## **NSW Roads and Maritime Services**

# **WOOLGOOLGA TO BALLINA | PACIFIC HIGHWAY UPGRADE SUBMISSIONS / PREFERRED INFRASTRUCTURE REPORT**

Chapter 4

November 2013

**Figure 4-23: Revised design to the Koala Drive access**

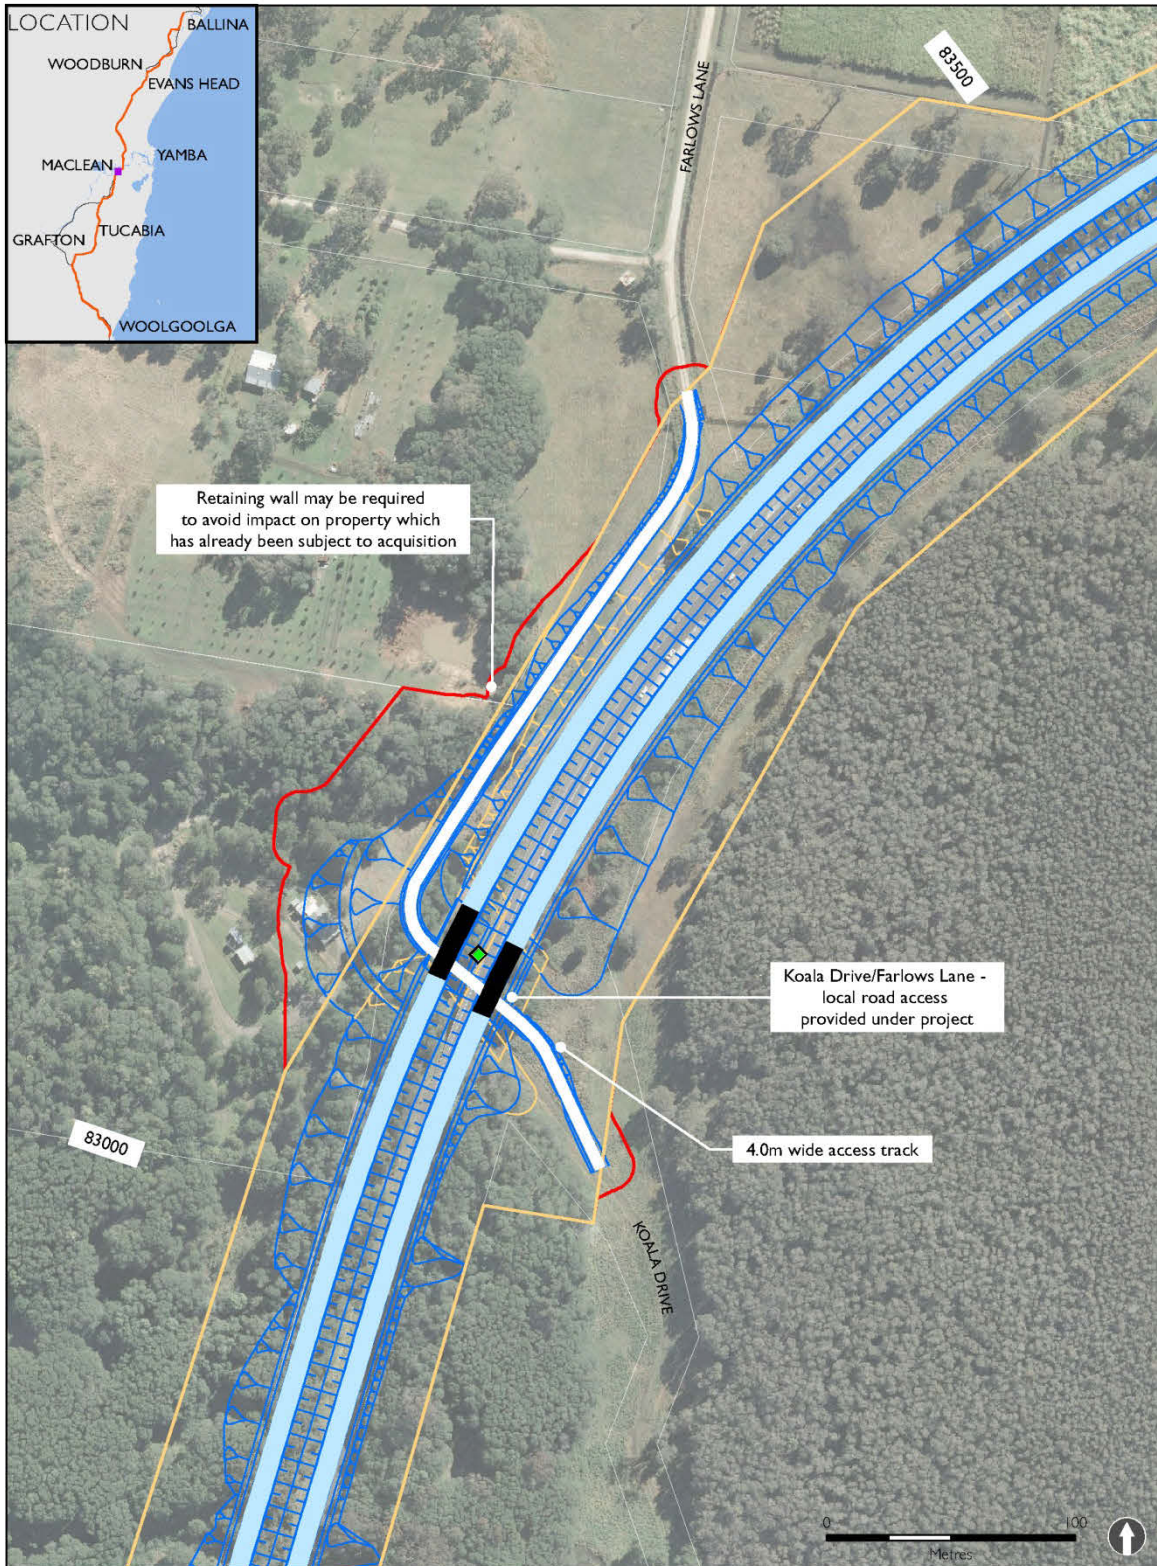
The design refinement shown in Figure 4-23 consists of:

The design refinement provides a formalised access track for Koala Drive to maintain access for the Yaegl Nature Reserve and agricultural properties.

The additional excavation required at Koala Drive would potentially generate erosion and sedimentation impacts during construction and operation. Similar to other earthworks activities required during construction of the highway, work at this cutting would be managed by a Construction Environmental Management Plan, as identified in Section 9.4 of the EIS. Around six temporary water quality basins proposed in the EIS would be within 100–200 metres of Koala Drive, due to its proximity to the nature reserve. The design refinement would not alter the proposed location of these temporary water quality basins.

The nearest residential receiver is around 180 metres north-west. The noise management level for this receiver is 53 dB(A) during proposed project hours, and 35 dB(A) during out-of-hours work. The EIS identified construction noise would exceed this target noise level, and so a Construction Noise Management Plan was recommended in section 15.5 of the EIS.

**Figure 4-24: Potential design for cycle access south of Yamba Road**

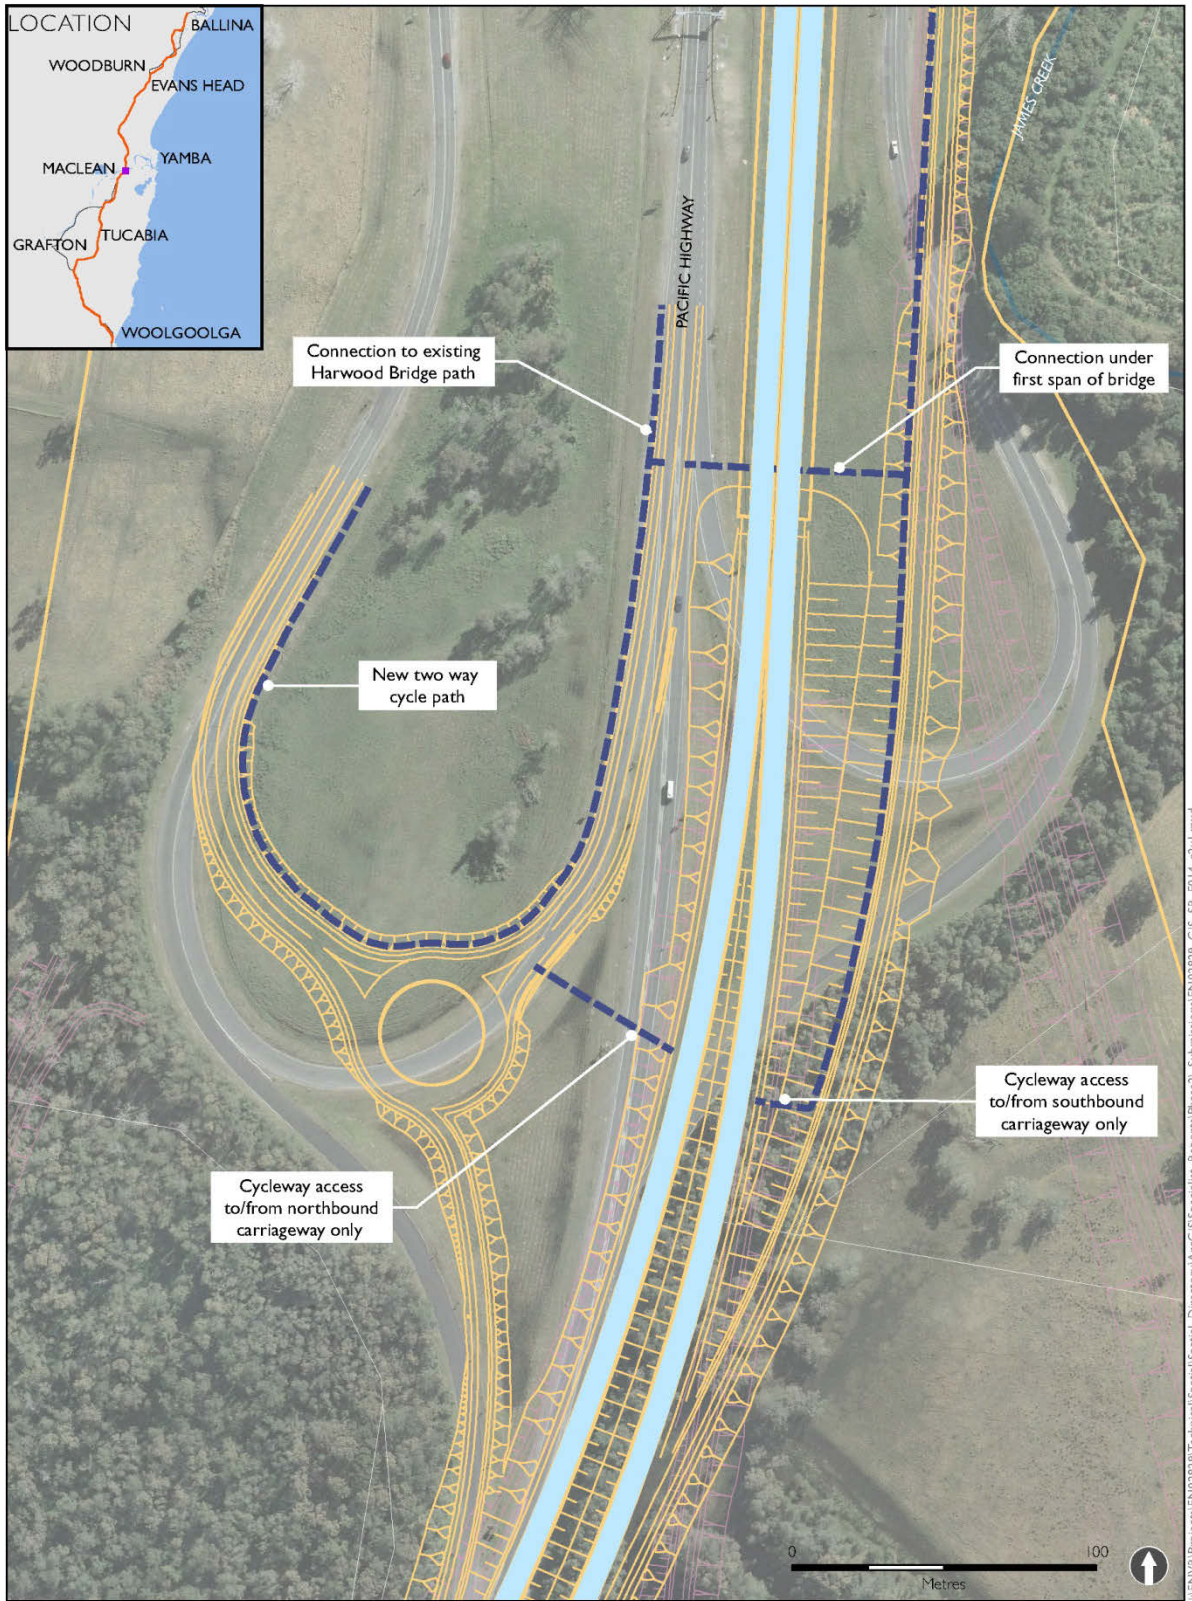
The design refinement shown in Figure 4-24 consists of:

- A new two-way cycle path to the south of Yamba Road and west of the existing highway. This would provide a dedicated pedestrian and cyclist access. To the west of the existing highway, south of Yamba Road at station 85.9, the cycle path would tie in to the existing path on Harwood Bridge (station 86.0).
- Cycle access to the northbound carriageway, adjacent to the interchange's western roundabout.
- Cycle access from the southbound carriageway, with a connection under the project providing a link to Harwood Bridge.
- Cycle access on the proposed highway bridge along the 2.5-metre outside shoulders.
- A cycleway connection to the east of the project to provide access either side of the project via a path under the first span of the proposed bridge, at station 85.9. A further connection between this crossing and Yamba Road would provide cycle access to the Harwood Bridge path.

The design refinement would provide formalised cycle access from the interchange at Yamba Road to the existing Harwood Bridge crossing of the Clarence River. This would improve cycle and, potentially, pedestrian access from Yamba Road to Harwood. The cycle access would provide formal crossing points under the interchange to provide safe access.

Figure 4-25: Revised design at Carrols Lane

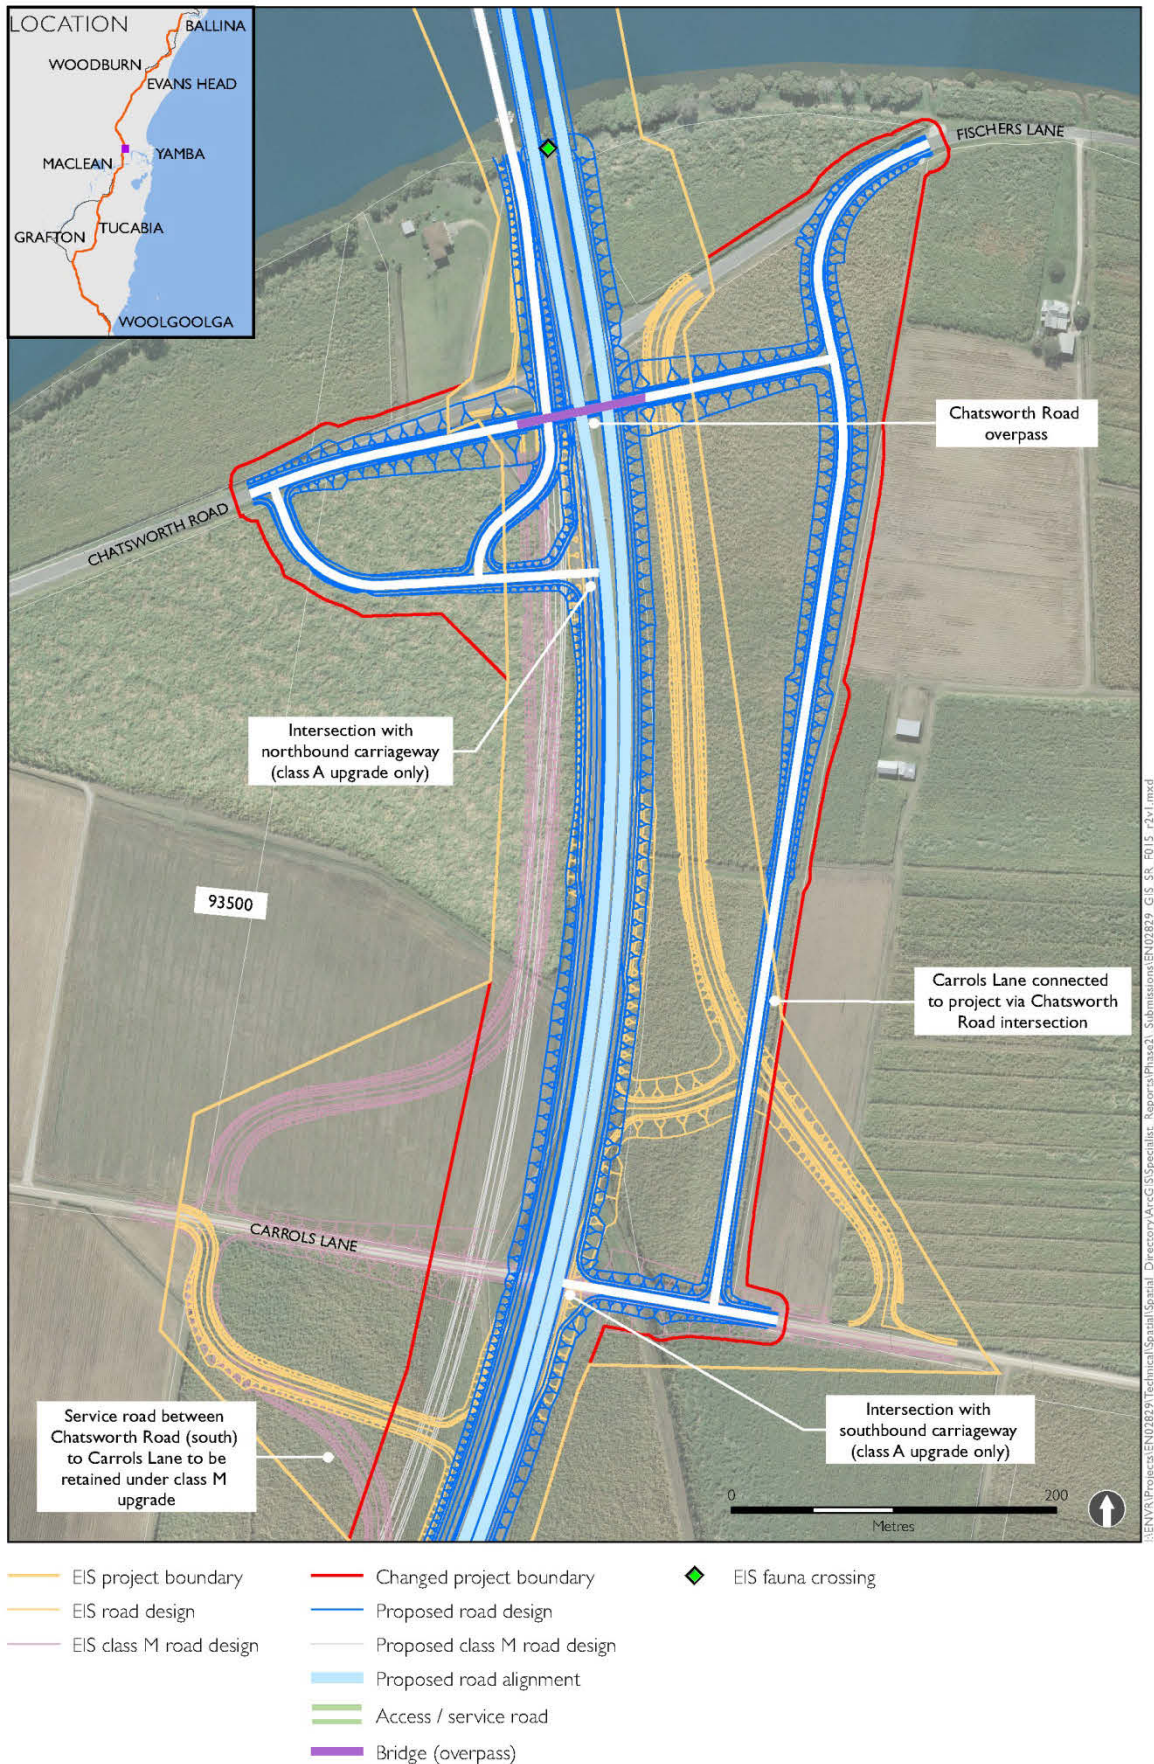
The design refinement shown in Figure 4-25 consists of:

- Relocating the Carrols Lane overpass 500 metres north to the existing intersection between the highway and Fischers Lane at station 93.8. This would provide a connection between Chatsworth Road (west) and Fischers Lane (east). The overpass structure would be around 70 metres long, and tie in to a realigned section of Chatsworth Road.

- A 200-metre access road immediately west of the highway, providing a connection between Chatsworth Road and the upgraded highway (station 93.7 to station 93.8). This access road would provide access onto the most western existing bridge of the North Arm. The intersection of the access road with the upgraded highway would be removed in the ultimate motorway upgrade.

- A 300-metre access road under the Fischers Lane overpass to provide a connection between the access road to the west of Chatsworth Road and the existing highway.

The overpass at Fischers Lane would require a similar sized fill embankment to that in the EIS design. The design refinement would reduce the access road extents required to the west and east of the upgraded highway. However, the access road between Carrols Lane and Fischers Lane would extend further east than shown in Figure 5-49 of the EIS.

Figure 4-27: Revised design at Mororo Road

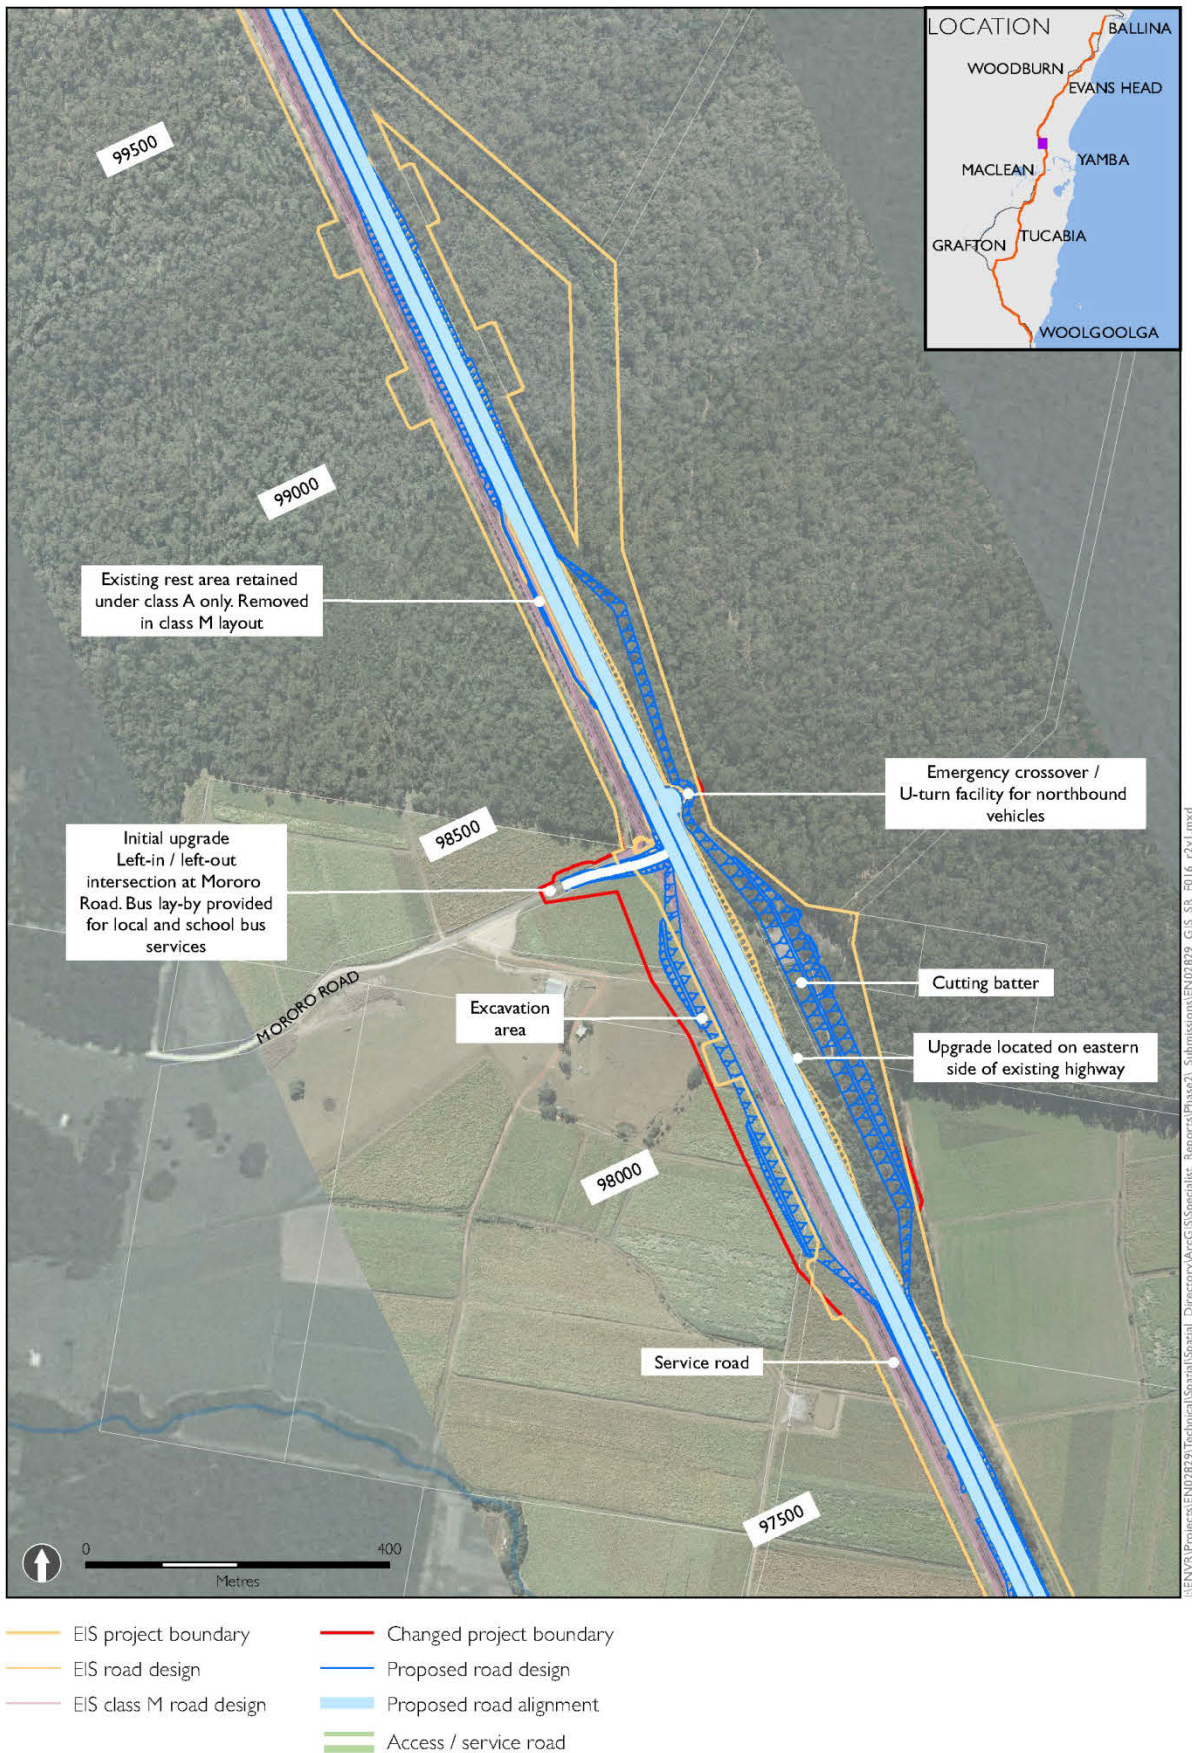
The design refinement shown in Figure 4-27 consists of:

- An alteration of the vertical alignment of the upgrade between stations 97.4 and 98.9, to deepen the road cutting with excavation either side of the project. The design level would range from around 10 metres to 30 metres AHD.
- Deeper cut batters that would extend the project boundary to the west.
- An alteration to Mororo Road to provide access to the project.
- The design for the ultimate motorway upgrade as described in the EIS design.
- Changes to the project boundary of around 50–100 metres to the west, along a 650-metre stretch of the upgraded highway. The eastern cutting would remain within the project boundary assessed in the EIS.

In section 6, there is a deficit of embankment material, which would require additional fill material to be imported to the site. It is possible that this would be imported from Section 3 of the project, where there is a large surplus. This would be a haul distance in excess of 28 kilometres. As well as resulting in increased cost of haulage, there would be social and traffic impacts, with haulage trucks needing to use the highway, passing through townships on the existing highway, including Ulmarra and Harwood.

The design refinement in this location would result in a broader footprint impacting a larger area (around 4.0 hectares) of remnant and regenerating vegetation than the EIS design (refer Table 4-29). The vegetation to be impacted consists of both remnant and regrowth dry open sclerophyll forest, commonly recorded in this location and no communities listed under the EPBC Act or TSC Act. No threatened plant species were identified from the field surveys. The condition of the habitat in this location varies from poor to moderate and exhibits a high weed density particularly along edge areas of the old and existing highway.

At this location, the EIS design would directly impact on 0.06 hectares of High Conservation Value Old Growth Forest. Due to the design refinement, this impact would increase to 0.20 hectares. However, while the change in design footprint increases the forest area to be cleared, the EIS Statement of Heritage Impact (SoHI) assumed removal of all High Conservation Value Old Growth Forest within the project boundary (amounting to 2.14 hectares). For this reason, there is no additional change to the impact on this item from that identified in the EIS and no mitigation or management measures are required beyond those identified in the EIS.
